SERVICE INSTRUCTION

Service Instruction No. 1565A
(Supersedes Service Instruction No. 1565)
Engineering Aspects are
FAA Approved

- SUBJECT:** Replacement Thermostatic Oil Cooler Bypass Valves
- MODELS AFFECTED:** All Lycoming engines using a thermostatic oil cooler bypass valve
- TIME OF COMPLIANCE:** At overhaul or when necessary to replace the thermostatic oil cooler bypass valve
- REASON FOR REVISION:** Clarify replacement valve part numbers for specific Lycoming engine models

Figure 1
Thermostatic Oil Cooler Bypass Valve

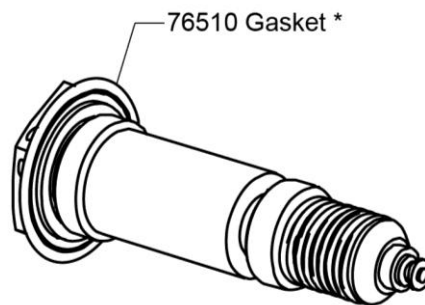
This Service Instruction is notification that the most currently available thermostatic oil cooler bypass valve P/N 53E22144 (Figure 1) is for all Lycoming engine models except TIGO-541-D1B and TIGO 541-E1A. Thermostatic oil cooler bypass valve P/N 53E22144 supersedes P/N 53E19600, 75944, and LW-10269.

For the TIGO-541-D1B and TIGO 541-E1A engine models, the correct replacement thermostatic oil cooler bypass valve is P/N 53E19980.

NOTICE: Both of the thermostatic oil cooler bypass valves P/N 53E22144 and P/N 53E19980 come with a gasket (P/N 76510) already installed. If only this gasket is to be replaced, order the replacement gasket by P/N 76510.
